03/30/2016

Subject: ClipperCreek comments addressing ENERGY STAR EVSE program Draft 3

Figure 3 Energy Star Graph of Data used for determination of 2.2W Criteria

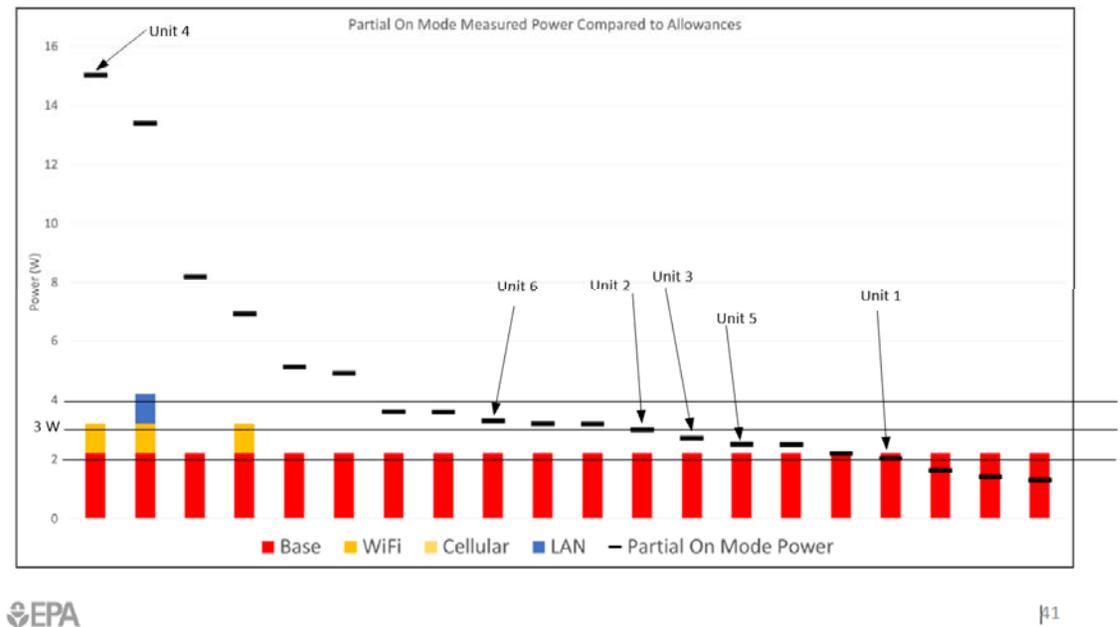
2. Energy Star staff manipulated ClipperCreek data with accuracies not represented by ClipperCreek and NOT supported by industry data

Reference table Figure 1, data presented with no digits to the right of the decimal point for accuracy as provided to Energy Star. This is because given the test procedure parameters and equipment, ClipperCreek was not able to represent any accuracy better than the nearest +/-1W. HOWEVER, as 6 out of 20 data points presented by Energy Star in **Figure 3** were ClipperCreek's products, with 5 out of the 6 presented as 3W or 2W, it is easy to see that the graphing of the data includes accuracies not proposed by ClipperCreek. Where are our products on this graph in the 2W or 3W positions? ClipperCreek presented 4 products that were represented as 3W, however only (1) 3W EVSE appears on the graph. Going back to our original spreadsheet, it could be seen that if an expansion of the data to the right of the decimal point is made, then there is a correlation to the graph is apparent, so apparently Energy Star staff restated the accuracy of our data.

Then a slice through 2.2W was presented as though it represented the industry as whole. Based entirely on incorrect and unsupported accuracy levels of ClipperCreek data in conjunction with the only other available data which did NOT COME from Manufacturers and did not have manufacture's endorsements or any traceability of accuracy as well. Not only is 2.2W way too low, the accuracy is NOT SUPPORTED by INDUSTRY provided data. What is the accuracy of the data that was provided by the 3rd party and who has validated it if not the manufactures? Criteria of 2.2W is not supported by the basic accuracy of the data presented.

Figure 5 Idle Mode from [EVSE Draft 1 Specification and Draft 3 Test Method Webinar](#)

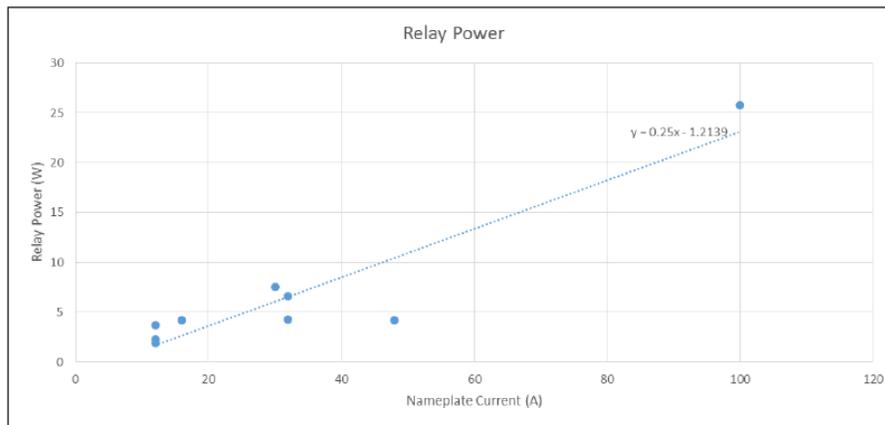
Essentially, E* staff's asserts it is necessary to set a standard for Idle mode. Of the 9 products that were submitted with idle mode data, it should be noted that of the 6 sets of data came directly from ClipperCreek products, the rest were not supplied directly by EVSE manufactures and may be invalid. At a minimum the data set certainly does not represent a cross section of product types or manufacturers across the industry. What products has data been supplied for? Do they represent "real" NRTL listed products or unpopular and ineffective market outliers?

Essentially, with a 6 of the data points out of 9 coming from ClipperCreek's product line, the determination of the idle mode criteria does nothing more than slice ClipperCreek's own product line down an arbitrary demarcation point.

Since ClipperCreek EVSEs serve different purposes and therefore must have different idle mode energy loss levels, ClipperCreek was essentially punished for supplying data and having a variety of products.

- 9 models in dataset analyzed for Idle Mode
- A new allowance term was introduced to the calculation for Idle State Power Requirement to reflect relay power, which increases with nameplate current
 - Seemingly the relay power varied with maximum nameplate current by a factor of 0.25 in a linear fashion

Figure 6 Idle Mode from [EVSE Draft 1 Specification and Draft 3 Test Method Webinar](#)

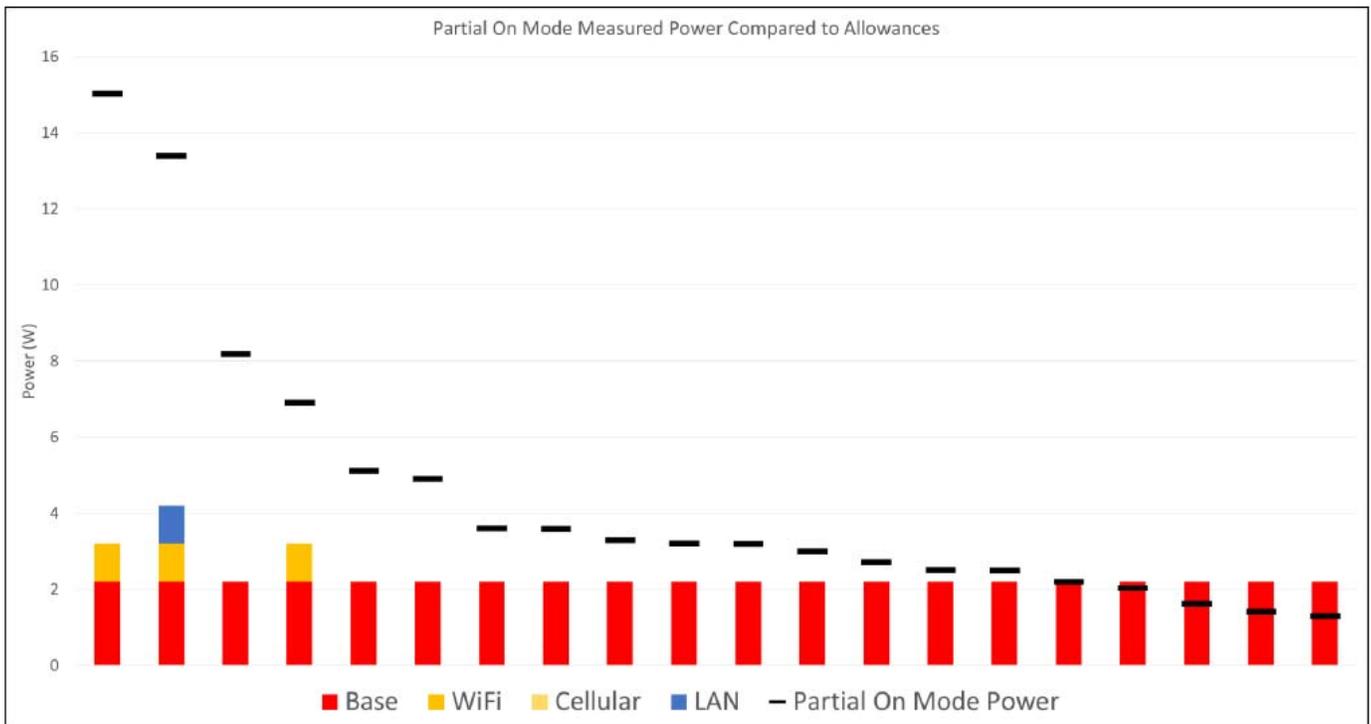
4. There was insufficient data presented for a determination of Partial On Mode

It is simply inappropriate to use information from an uncertified 3rd party for the determination of EVSE energy loss. There are more than 100 models of EVSEs on the market, data needs to be collected from more than one manufacturer.

What products has data been supplied for? Do they represent “real” NRTL listed products or unpopular and ineffective market outliers?
